Docket No. 040-02061

Kerr McGee Corporation  
ATTN: W. S. Shelley, Vice President  
Nuclear Licensing and  
Regulation  
Kerr McGee Center  
Oklahoma City, OK 73125

Thank you for your letter of January 5, 1984, describing the progress of your investigation into possible biases in the analysis for airborne lead-212.

Kerr-McGee has determined the airborne Pb-212 concentrations reported for the West Chicago Facility are high by 32.5 percent. As discussed below, there is a 23 percent bias in the results due to an unknown (at this time) cause associated with the gas proportional counting system used to analyze the air sample filters and a 9.5 percent bias due to the transient equilibrium that exists with Pb-212 and Bi-212. In view of this determination, the Pb-212 concentrations reported to date should be multiplied by 0.7 to correct for the bias. Pending repair of the system, concentrations reported in the future will reflect this correction factor.

ALPHA SPECTRAL ANALYSIS OF SOURCES

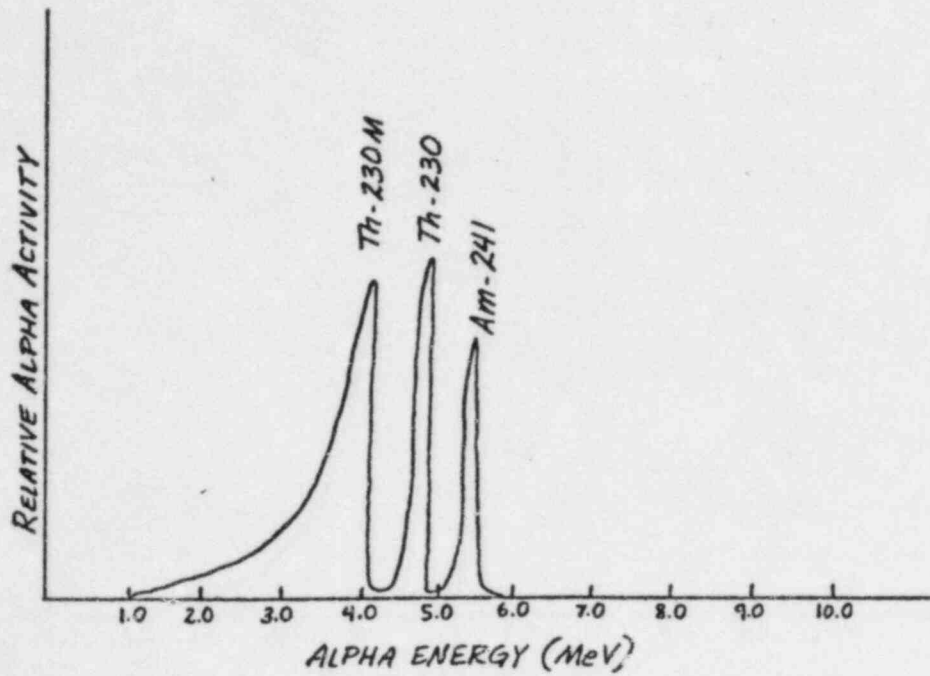
A third approach used to confirm system bias involved analyzing responses to three sources of varying alpha energy emissions. The three sources were Am-241 (5.49 MeV -- 85 percent and 5.44 MeV -- 13 percent), Th-230 (4.68 MeV -- 76 percent and 4.62 MeV -- 24 percent) and Th-230 modified (approximately 3.9 MeV). (The Th-230 source was modified by placing mylar (0.85 mg/cm<sup>2</sup>) over it to attenuate the alpha energy.) The results of analyses of these sources are shown in Attachment 4, along with an alpha spectrum analysis of the sources. The fraction of events appearing in the alpha channel and in the beta channel are shown and demonstrate that as the alpha energy increases, the number of alphas appearing in the alpha channel increases. This condition would not occur with a properly operating system.
